Report to Nuclear Utility Management

Quarterly Report
March, 1981

Subject: Surveillance Testing of Reactor Trip Circuit Breaker
San Onofre Nuclear Generating Station
Units 2 and 3

AN ONOFFRE NUCLEAR GENERATING ST ON
STARTUP PROBLEM REPORT
JOB NO. 10079

UNIT 2 - 2L32 UNIT 5 - 3L32 UNIT 2 - 2CR56 UNIT 5 - 2CR56	DATE: 6-10-75 SCALE: 1/8" = 1" DRAWN: J. H. H. CHECKED: J. H. H. SHEET NO: 1 DRAWING NO: 8052-B5.3
--	---

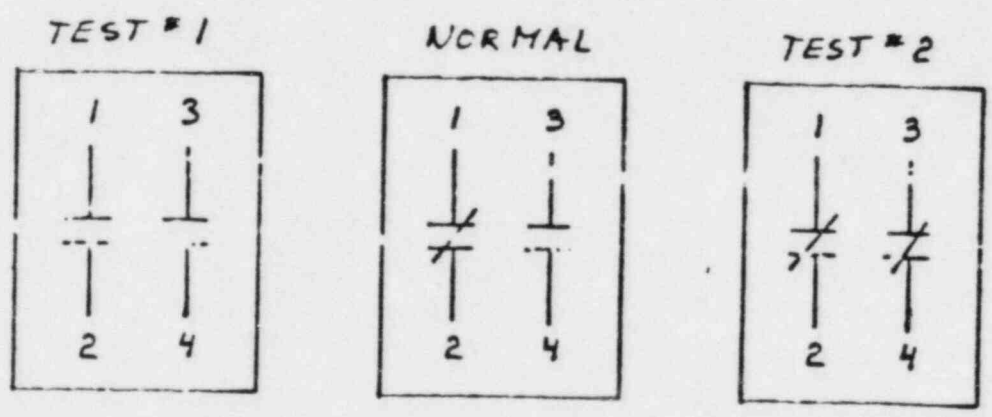
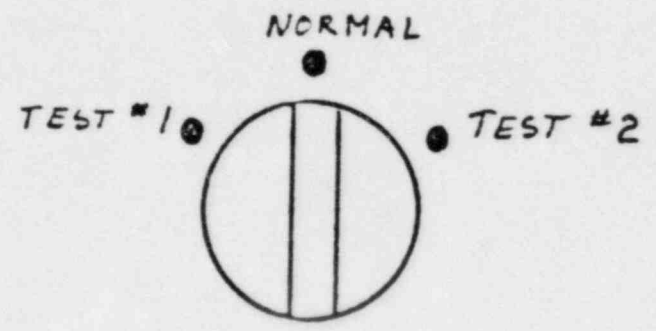
The present design of the reactor trip circuit breaker does not permit independent actuation of the undervoltage trip and the shunt trip devices during normal surveillance testing. Such a design has been recommended in (NRC's) IE Circular No. 81-12 to ensure continued operability of the dual trip feature.

Please proceed with a design change to provide this feature. We request that the documentation of this design change be submitted to us by January 31, 1982.

We have attached for your use a copy of SONGS 2 & 3 Startup Problem Report 2213, in which a schematic for implementing this design change has been suggested.

Reference (A) noted that the present design of the reactor trip circuit breaker does not permit independent actuation of the undervoltage trip and the shunt trip devices during normal surveillance testing. CE was requested to implement a design change to provide independent testing of these trip devices.

CE has reviewed the reactor trip circuit breaker design and has developed a procedure to accomplish independent testing of these trip devices compatible with the present design. This procedure is to be performed during a refueling outage; hence the independent testing is conducted every 18 months as required by the San Onofre Unit 2 Technical Specification, Table 4.3-1. Therefore, a design modification is not necessary. Normal surveillance testing will continue to test operability of the circuit breaker.
